# Town of Hilton Head Island Regular Design Review Board Meeting

Tuesday, July 10, 2012

PROJECT NAME: Supervisor's House Renovation & Addition  
(The Coastal Discovery Museum at Honey Horn) – ALTERATION & ADDITION

PROJECT NAME: Coligny Beach Park – ALTERATION & ADDITION

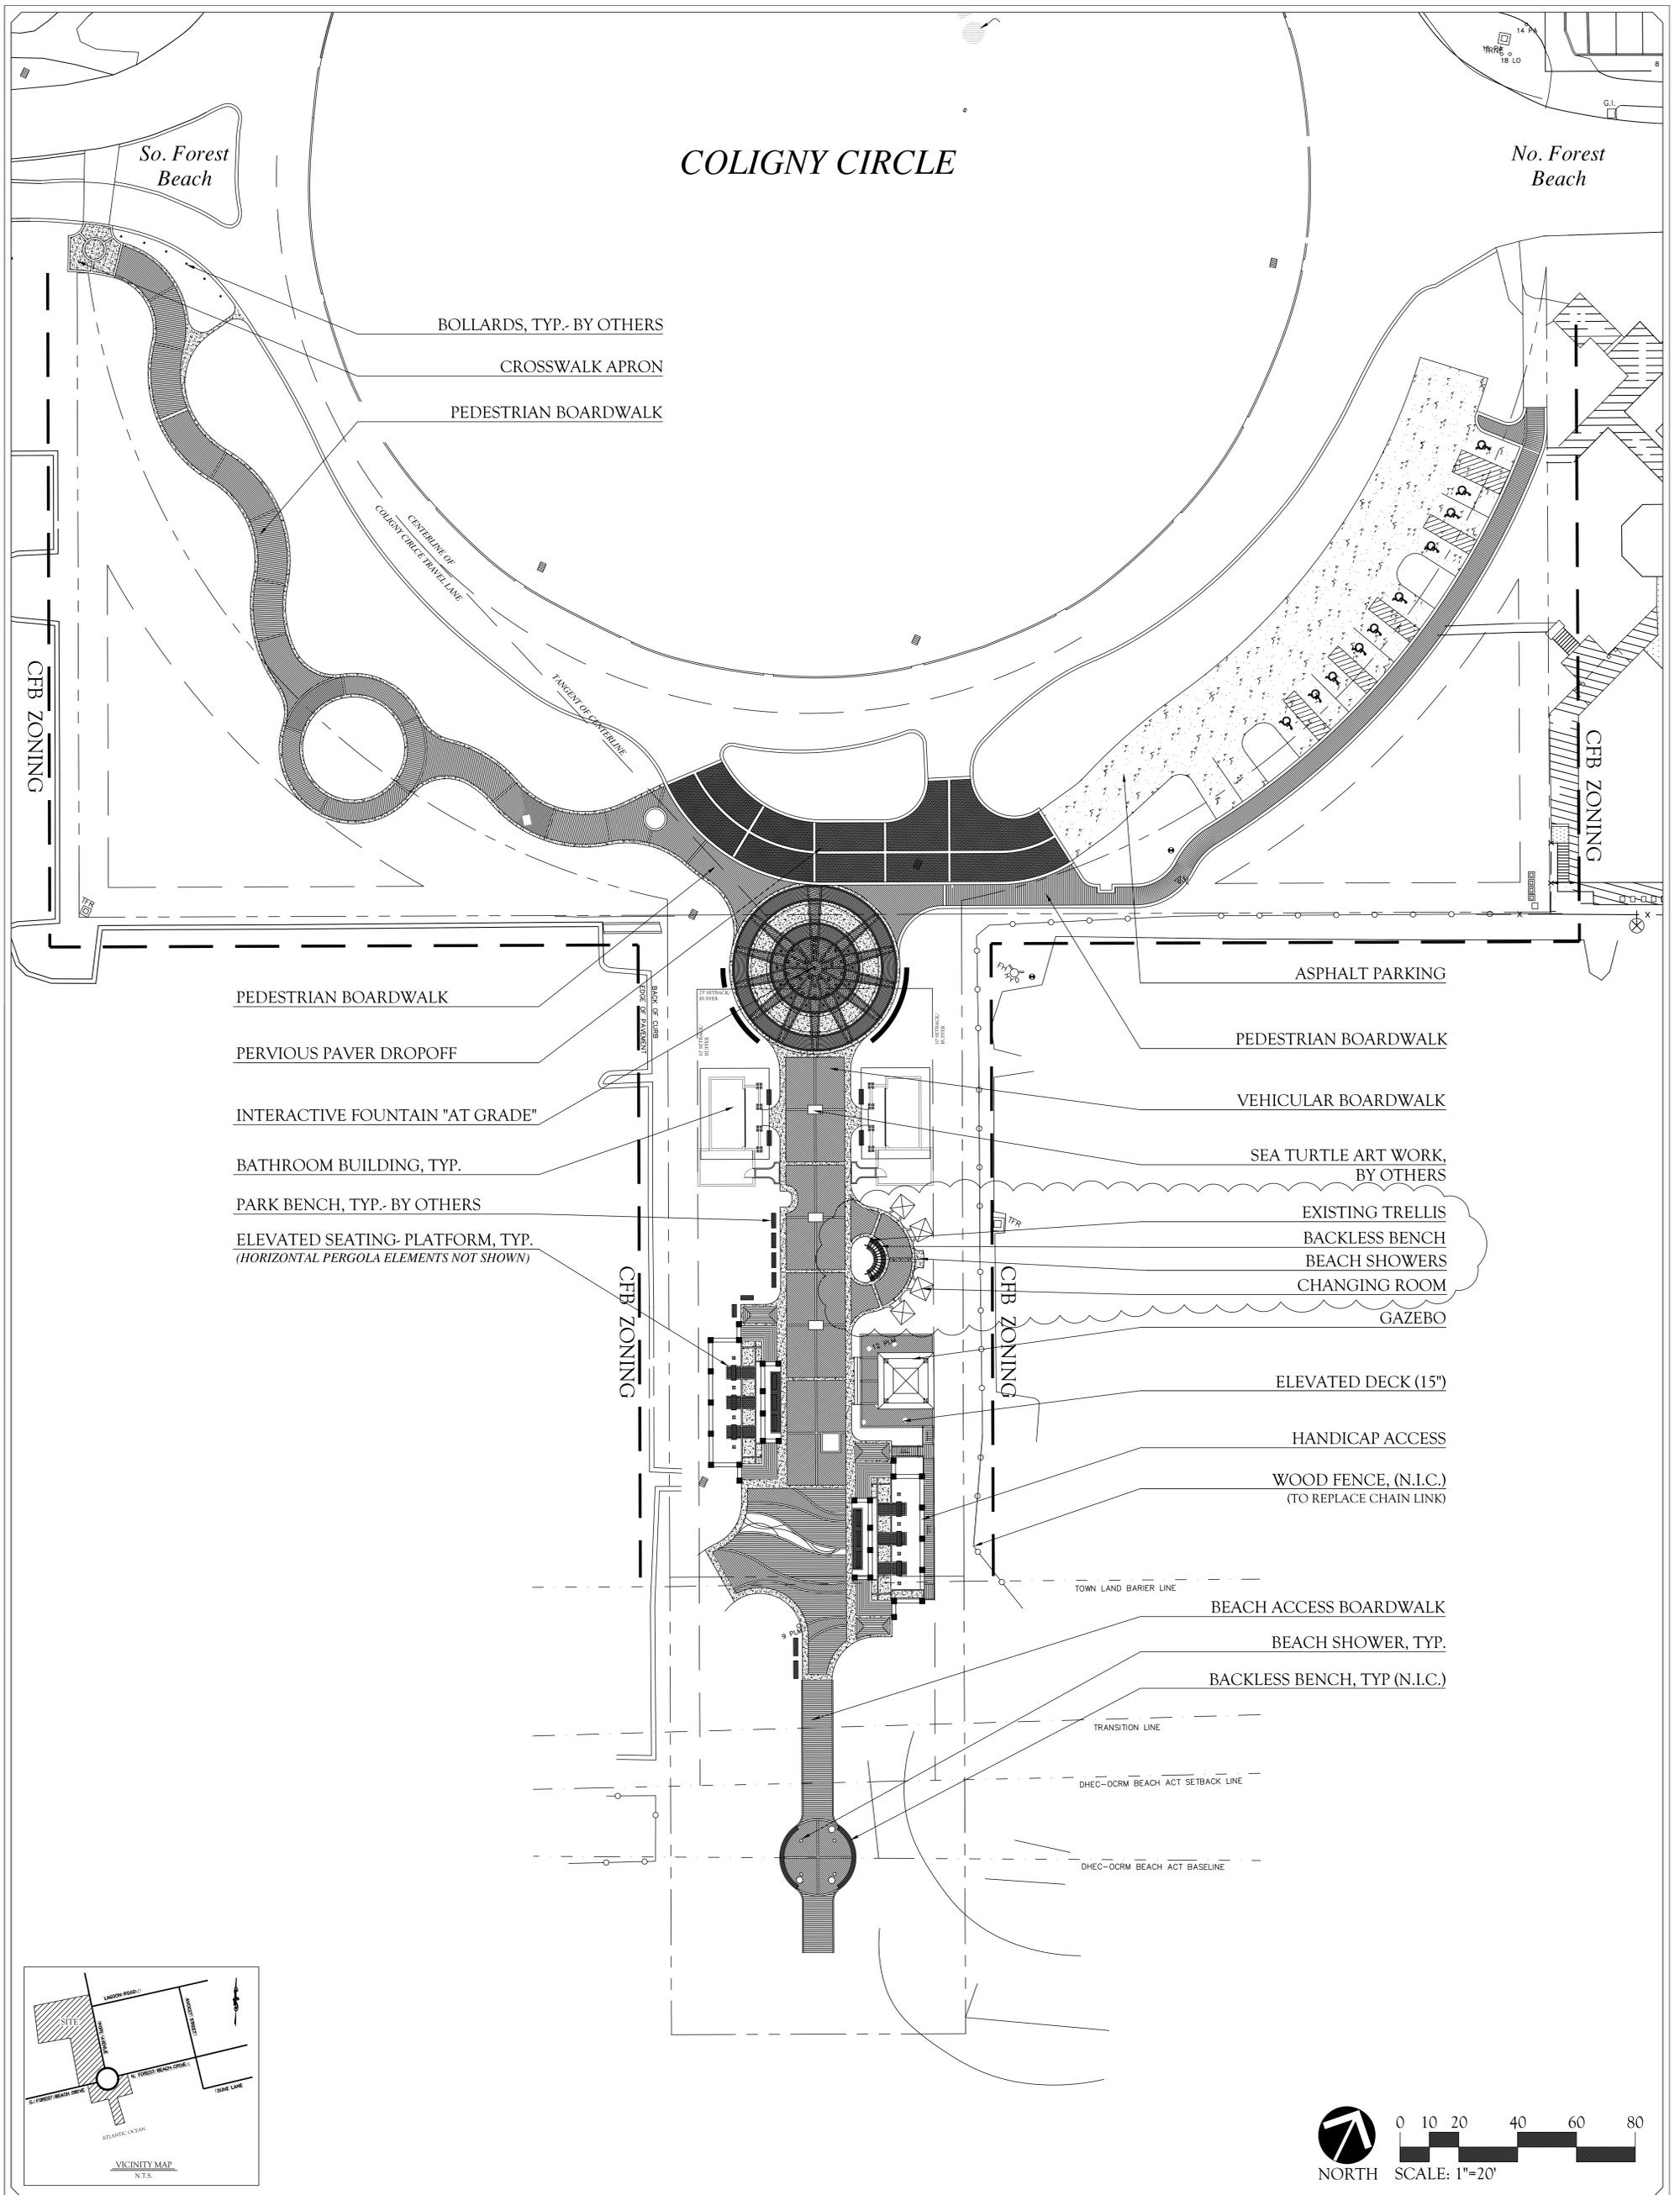
Due to on-going safety concerns, mitigation of drainage issues is proposed through the addition of a curved backless bench (to match existing bench detail) and relocation of beach showers to other side of path. Staff recommends approval of the project as submitted.
